City of Beaumont Wastewater Treatment Plant Salt Mitigation Upgrade Project Change Order No. 15

April 14, 2020

Contractor: W.M. Lyles Co.	Original Contract: \$ 53,312,000.00	Calendar Days: 820	Comp. Date: 1/26/2021
Project Name: Wastewater Treatment Plant Salt Mitigation Upgrade Project	Previous Approved Changes: \$1,640,717.91	95	5/1/2021
Contract No.: C18-80	This Change: Amount \$79,713.39	0	
CO Number: 15	Revised Contract: \$55,032,431.30	915	5/1/2021
	Previous Phase 1 Completion Date		4/26/2020
	Revised Phase 1 Completion Date		4/26/2020

SHEET 33 OF 172
NI-04A

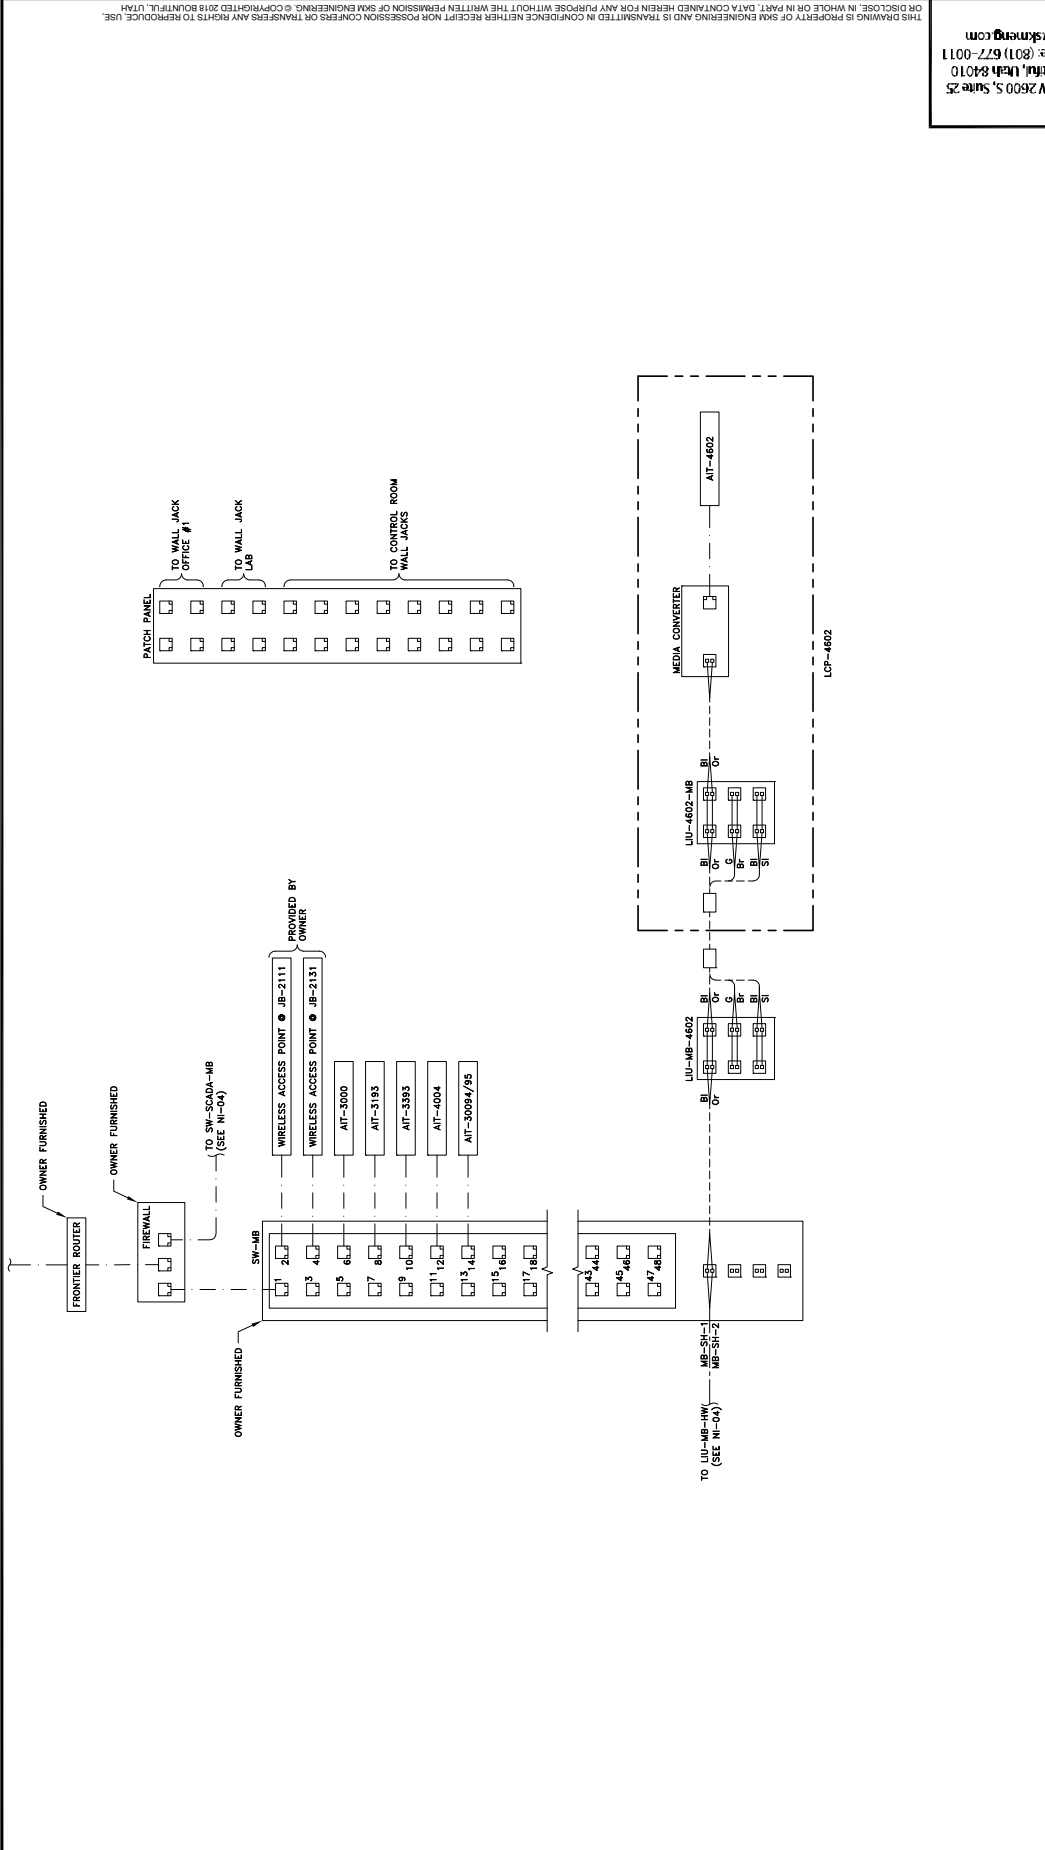
NI-02 The local interface unit LIU-HW-7410 has been removed, and LIU-HW-7472 has been added to provide communications from LIU-HW-MB to LCP-7472.	
NI-04 and NI-04A Sheet NI-04A has been added to show communication to HACH instruments at the anoxic/aeration basins, brine lines and in the MBR building. Communication wires have been added at LIU-MB-HW and for the firewall at SW-SCADA-MB.	
NI-07 Networking information for AIT-7472 has been added.	
I-19 Networking labels at CTC-HW have been updated and now include LIU-HW-7472.	
I-24 Networking labels at CTC-MB have been updated and now include LIU-MB-4602 and SW-MB.	
I-25 Connections for SW-MB and the associated firewall have been added.	
I-33 and I-34 The wiring diagram and panel drawings have been added for LCP-4602. Sheet I-34 also shows the layout for LCP-7472.	
GE-08 and LE-07 The anoxic/ aeration basin junction boxes now have wireless access points as shown in the updated detail on GE-08, at the locations shown on LE-07.

CITY OF BEAUMONT
SALT MITIGATION WWTP UPGRADE
INSTRUMENTATION - PLC DRAWINGS
LCP-4602 & LCP-7472 PANEL LAYOUT

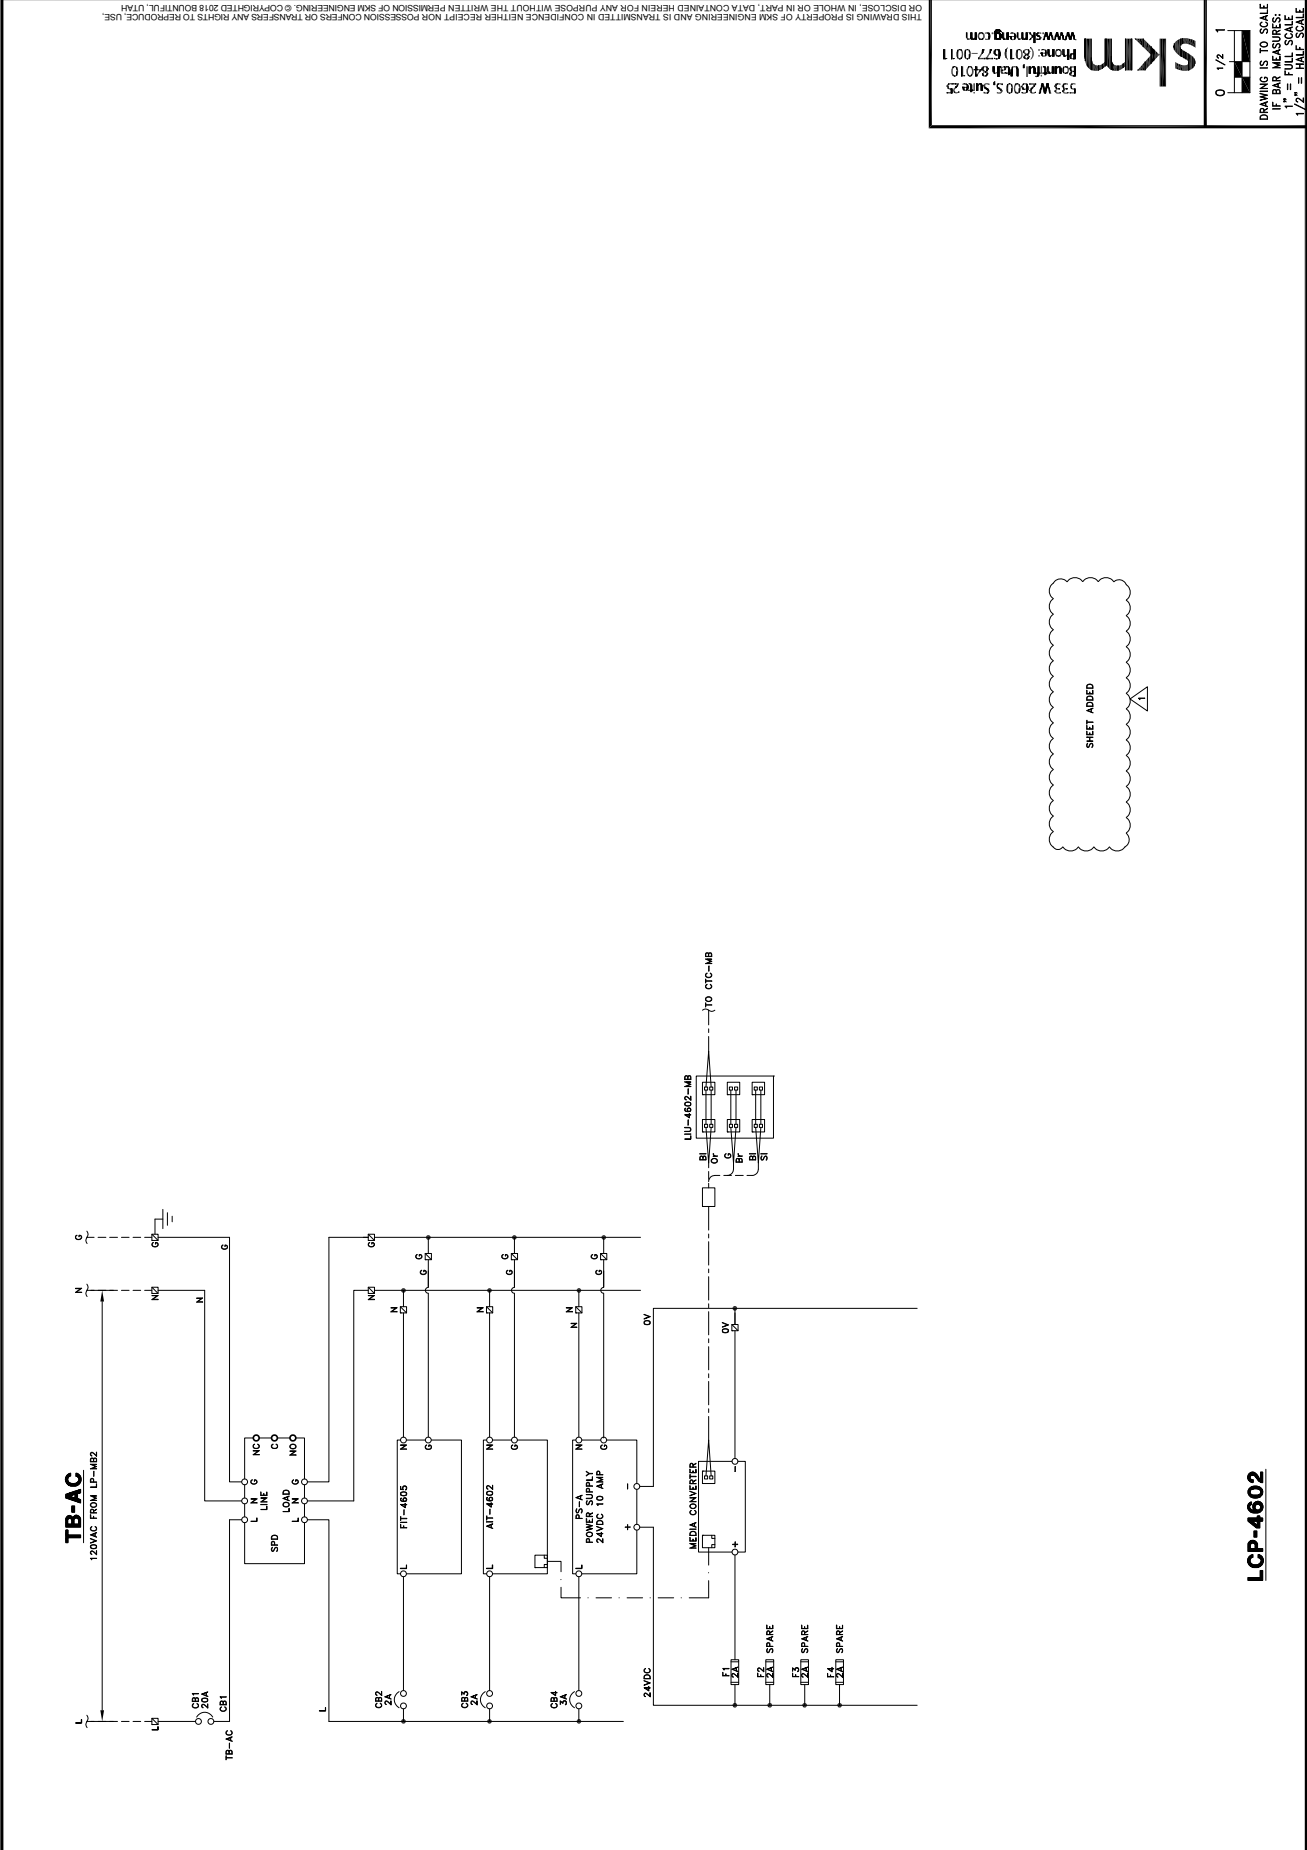
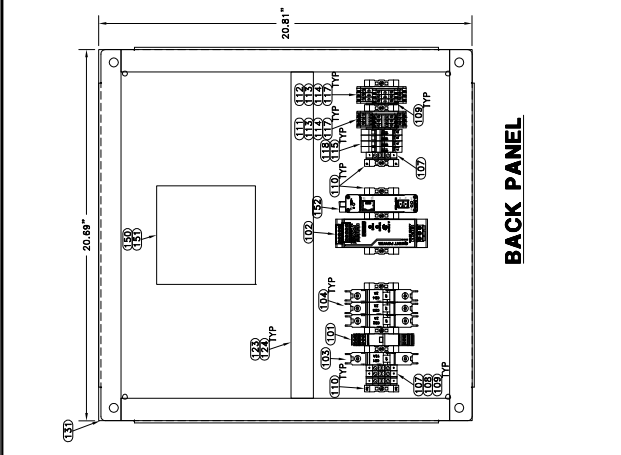
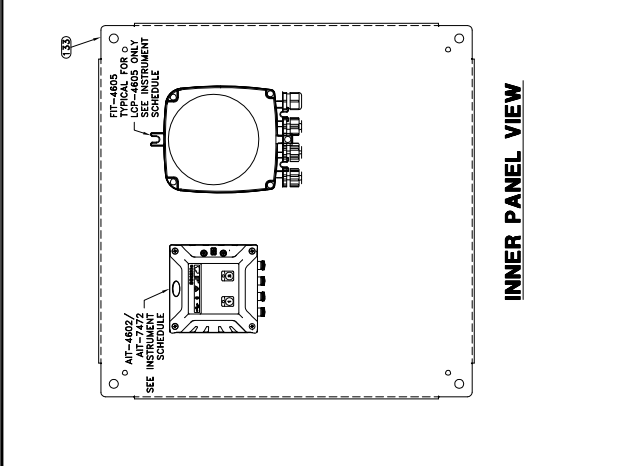
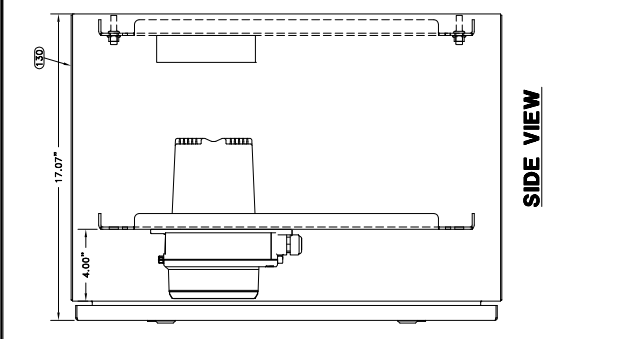
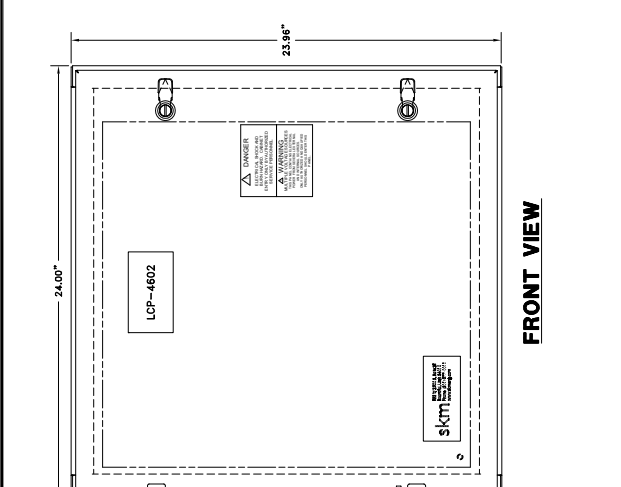
- Provide LCP-4602 Based on Drawing SE-03
 - o 36HX24”Wx12”D 316SS NEMA 4X Enclosure
 - o Based on drawings. Additional isolation transformer and GFCI required for UL listing of panel to supply 120V transmitters which are not specifically UL listed
 - o Standard swing-out panel will not have 4” clearance to front, so taller panel is used to allow room for rear panel mounting of transmitters. Custom swing out may be an option.
- Update CTC-HW and CTC-MB Drawings

LCP-4602 has been added at the brine meter vault and houses AIT-4602, AIT-4603 and FIT-4605.

SHEET 92 OF 172
SE-03

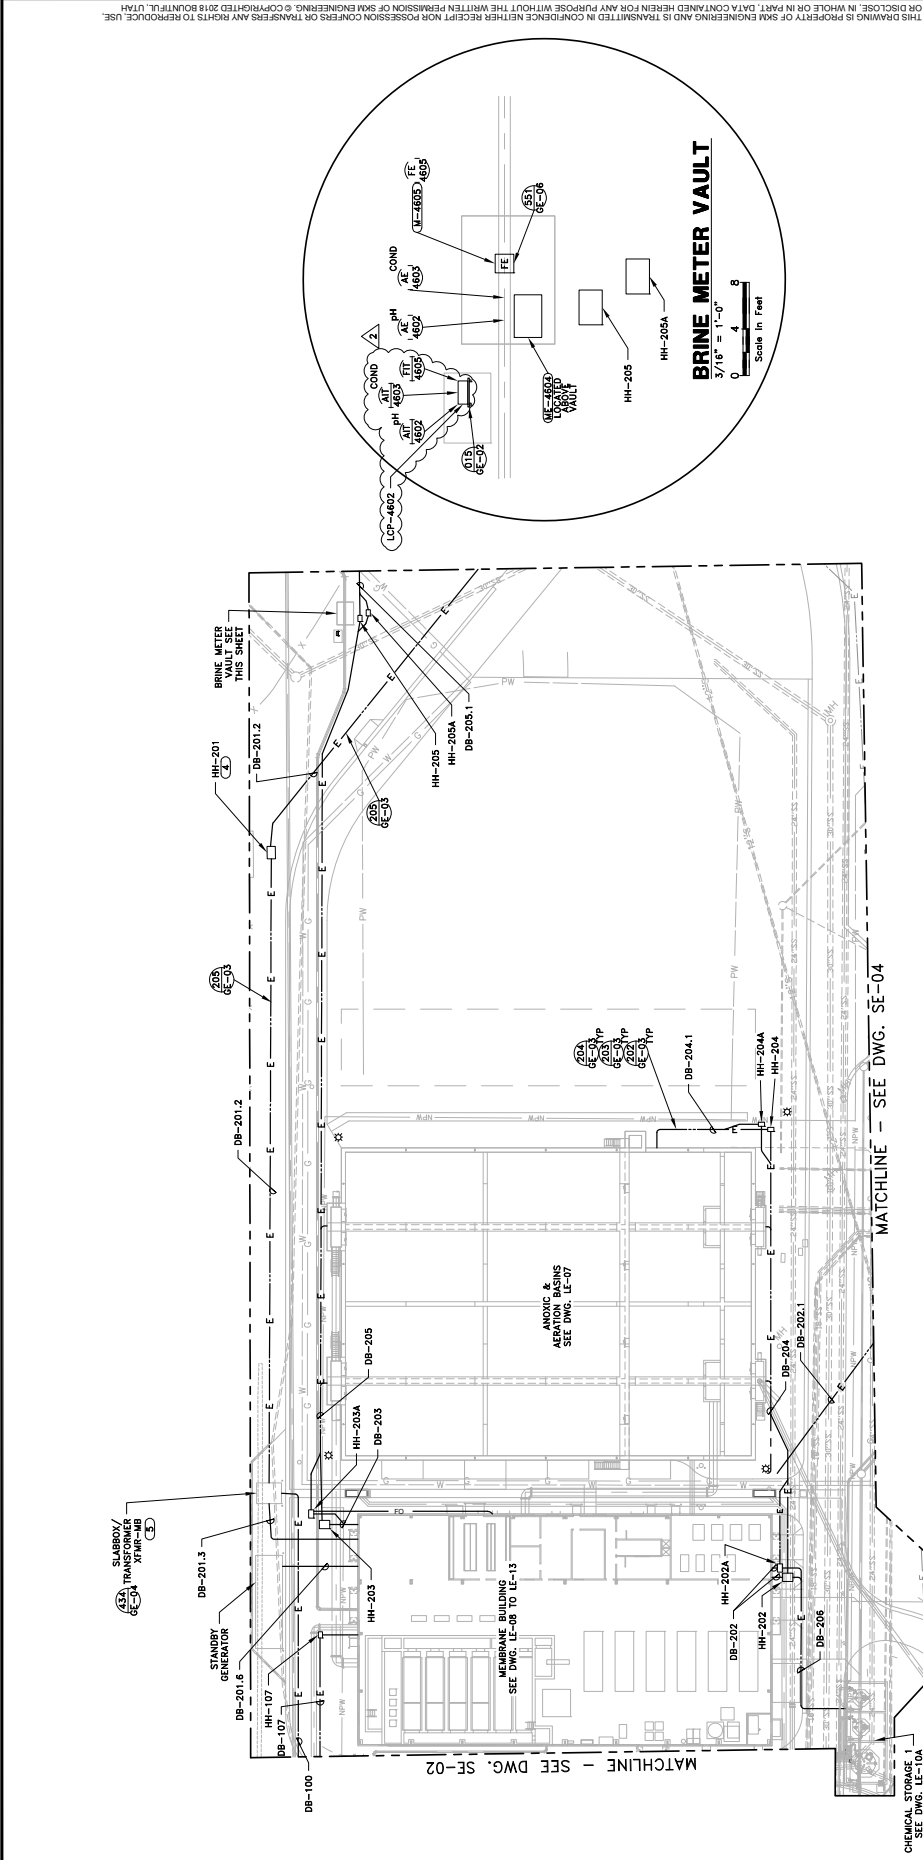
SE-03

SHEET 106 OF 172
LE-13

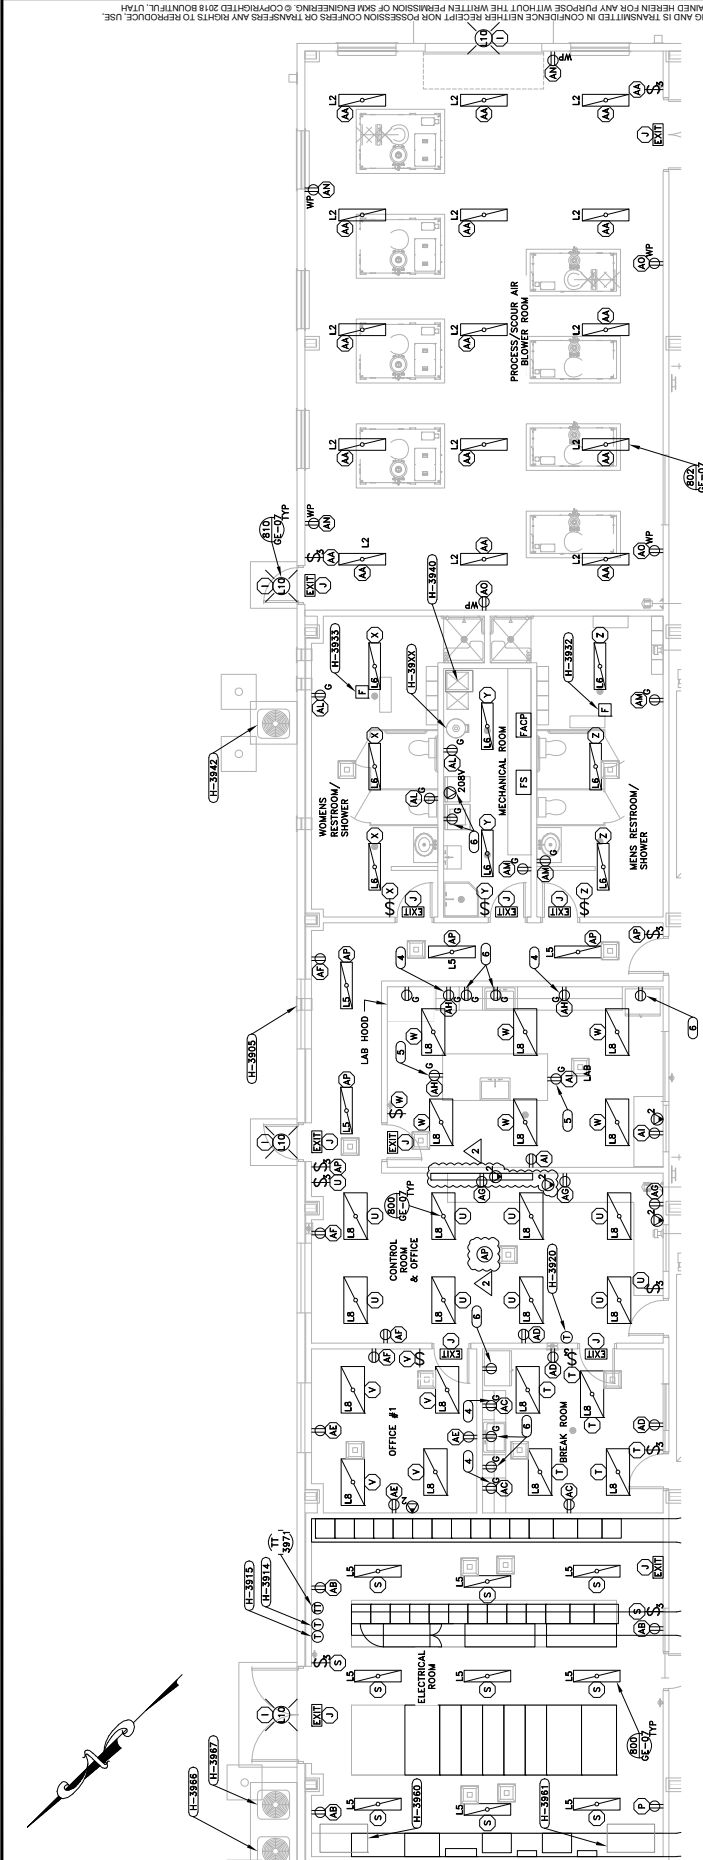
LE-13

A television and data outlets have been added in the control room and office area of the membrane building. The television will be provided and installed by the Owner.
